20th March, 1981.

IAEA - CN-39/58 "Towards a More Forgiving Reactor".

ERRORS IN THE ORIGINAL STOCKHOLM PREPRINT
(discovered since the Meeting of 21 October 1980).

Fig 5
LWR COOLING

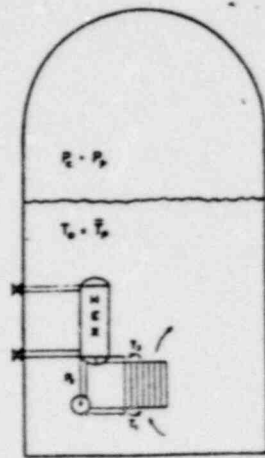
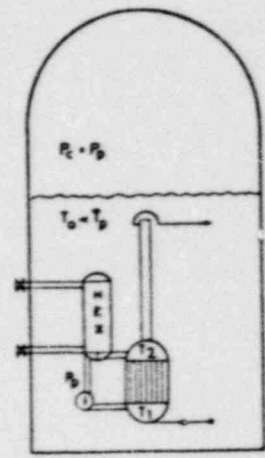
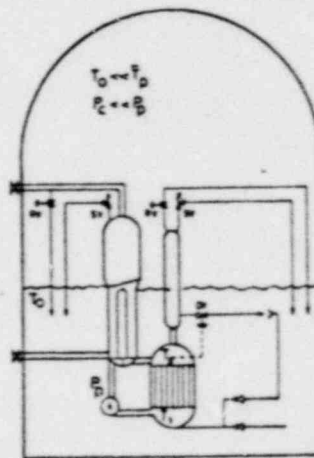
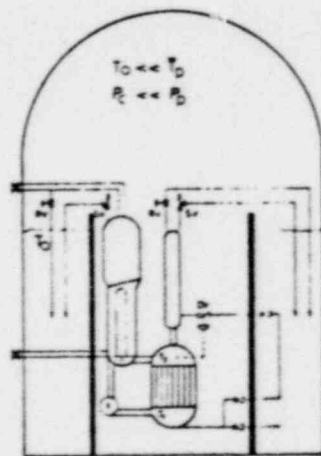
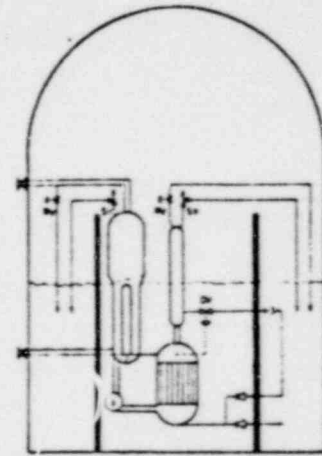
I enclose some amendment sheets. The only numerical change concerns the heat dissipation capacity of a natural draught chimney (Fig. 3d) and, while improved calculations have predicted an increase in heat transfer, the change is not significant in the overall context. The remaining changes are of a typographical nature.

Revised copies of figures attached.
